UNCOMPENSATED IONIZATION CHAMBER TYPE 8137

The following proposed re-registrations are hereby requested.

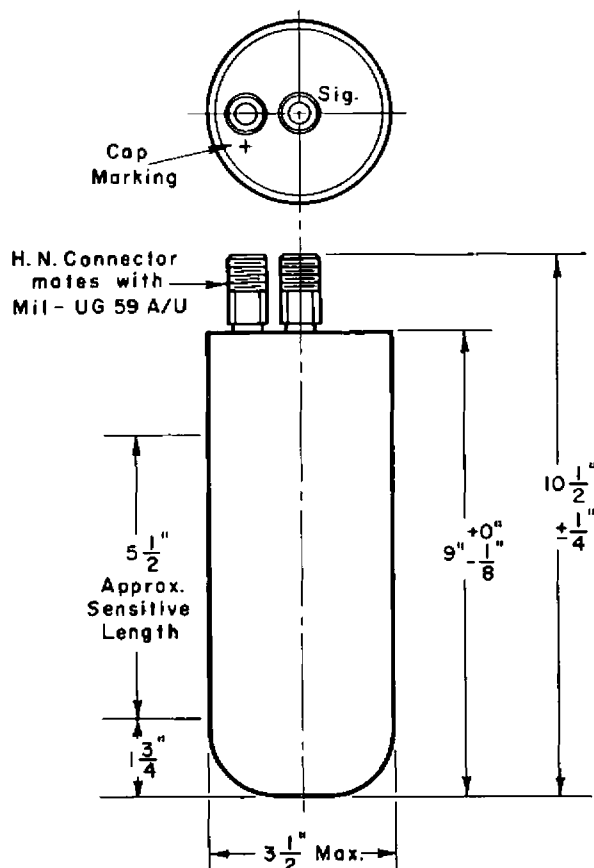
ITEM	AS REGISTERED	AS PROPOSED
Tube Type: 8073		
Rel. No. 3310		
Under Mat'ls:		
Neut. Sens. Mat'l.		
Total Quantity	1.72 Grams	1.68 Grams
Tube Types: 8105 8137 8214		
Ret. No. 3476 3522 3822		
Under TYP-OPER.		
Gamma Sens. (8137 only)	5×10^{-12} A/R/hr.	3.5×10^{-12} A/R/hr.
Un-Comp.	5×10^{-12} A/R/hr.	3.5×10^{-12} A/R/hr.
